Government of India
(Ministry of Railways)
Research Designs & Standards Organisation
Manak Nagar, Lucknow-226 011

MODIFICATION SHEET NO.- ELRS / MS / 0324

TITLE: Provision of "Oil Trap Chamber" in Drain Pipe of Conservator Tank of Locomotive Transformer

SKEL No. 4669 "Transparent Oil Trap Chamber".

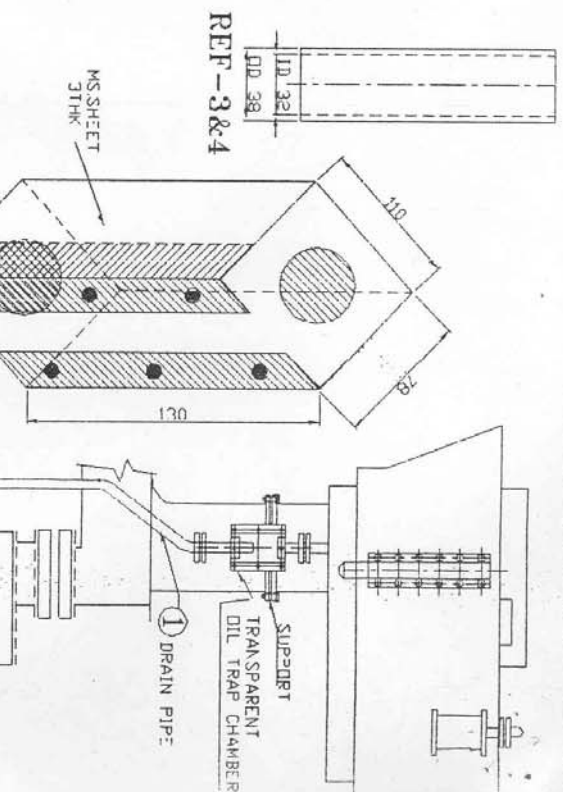
- 2.1 .Fabricate Oil Trap Chamber as per RDSO Drawing No SKEL-4669.
- 2.2 Disconnect the flange holding the top and bottom portion of the drain pipe..
- 2.3 Assemble the fabricated oil trap chamber in between the lower and the upper portion of the existing flanges of the drain pipe as indicated in Drawingg.
- 2.4 Cut the extended portion of the drain pipe from the bottom.
